APPEAL SUMMAR		
Status: Decision Rend		
Appeal ID: 15935		Project Address: 915 NE Schuyler St
Hearing Date: 10/11/17	,	Appellant Name: Sebastian Busby
Case No.: B-004		Appellant Phone: 5033880803
Appeal Type: Building		Plans Examiner/Inspector: Emily Hays, Thomas Ng
Project Type: commerc	ial	Stories: 9 Occupancy: RHd - High Density Residential Construction Type: TYPE 1: FIRE RESISTIVE
Building/Business Nar	me: Dahlke Manor (Home Forward)	Fire Sprinklers: Yes -
Appeal Involves: Addit	ion to an existing structure	LUR or Permit Application No.: 17-194718-LU - Radon Mitigation
Plan Submitted Optior [File 4]	n: pdf [File 1] [File 2] [File 3]	Proposed use: Radon Mitigation System
PPEAL INFORMA	TION SHEET	
Appeal item 1		
Code Section	OSSC 1812.3.7.5 - Termination	
Requires		ESDs shall extend through the roof and terminate at least 6 nd at least 10 feet (3048 mm) from any operable openings or
Proposed Design		will exhaust sub-soil radon gas to the outdoor air at a distance al ft from any balcony or operable window AND 10ft or greater oofline.

CASE FILE NUMBER: LU 17-194718 HR – RADON MITIGATION

High-Rise Multifamily Radon Mitigation Proposal

Work Performed At: 915 NE Schuyler St Portla

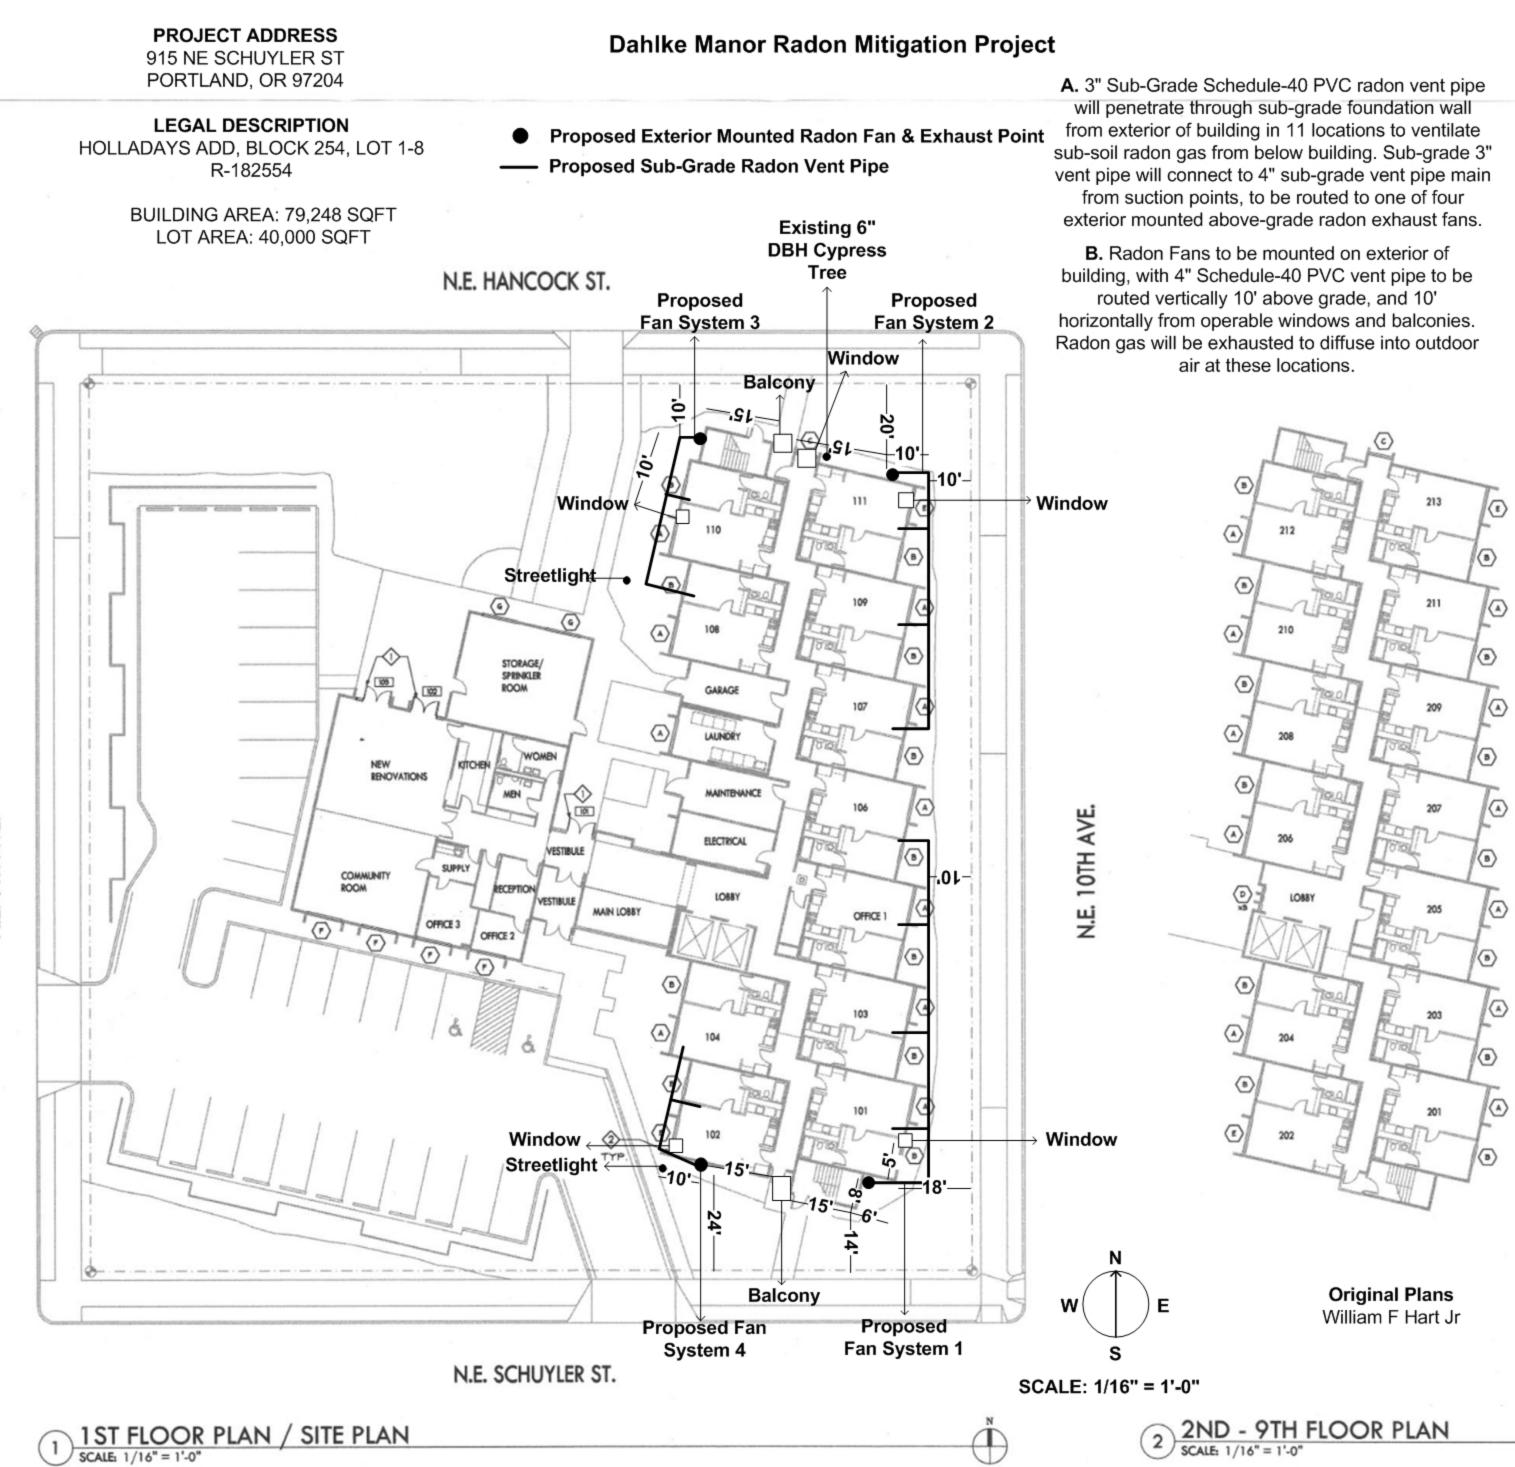
Reason for alternative	•	ly high-rise building. Following OSSC 1812.3.7.5 would require fline, which would impact the following:
	Significantly increased cost of project	
	Would require installation of scaffold	ling on the building.
	Would require installation of scaffold Would reduce the aesthetic value of	
	Would require installation of scaffold Would reduce the aesthetic value of four corners of the building.	ding on the building. f the building by exposing ventilation pipe up the entire side of
	Would require installation of scaffold Would reduce the aesthetic value of four corners of the building. Would reduce radon mitigation syste	ding on the building. f the building by exposing ventilation pipe up the entire side of em performance, requiring potentially multiple fans per vent
	Would require installation of scaffold Would reduce the aesthetic value of four corners of the building. Would reduce radon mitigation syste stack to create enough suction in ve	ding on the building. f the building by exposing ventilation pipe up the entire side of em performance, requiring potentially multiple fans per vent ent pipe to mitigate the radon issue in the building.

life safety requirements of code as radon gas diffuses to a non-harmful concentration within 10ft of

the termination point, removing the risk of radon re-entering living spaces or pedestrians being exposed. Gas will be expelled at a 90' angle away from building, removing risk of water vapor accumulate or irradiation of building materials.

Termination of radon vent: Granted provided a minimum of 30" x 30" clear space is maintained in front of the fan and a minimum of 36" x 36" is maintained in front of the electrical disconnect.
